← Oversize Rolls
LINOTYPE IMPROVEMENT SHEET
NO. 307

WISE CLOSING & JUSTIFICATION LEVERS (ASSEMBLED) (42EMS)

MERGENTHALER LINOTYPE COMPANY, Brooklyn, N.Y.

February 14, 1951.

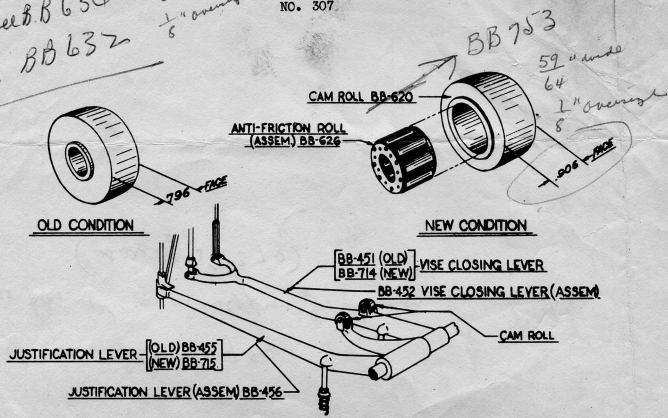
The width of the Cam Roll has been increased on both the Vise Closing & the Justification Levers to insure the roll riding on the full face of the cam and an Anti Friction Roller has been added.

Can be applied to all outstanding (42 Em) Machines by replacing the present Justification Lever (Assembled) & Vise Closing Lever (Assembled) with Justification Lever (Assembled) (BB-456 with Wide Roll) & Vise Closing Lever (Assembled) (BB-452 with Wide Roll) or by milling the Cam Roll slots in both existing Levers to .922 plus .002 minus .000 and replacing the present Cam Rolls with Cam Roll (BB-620) and Anti Friction Roll (Assembled) (BB-626).
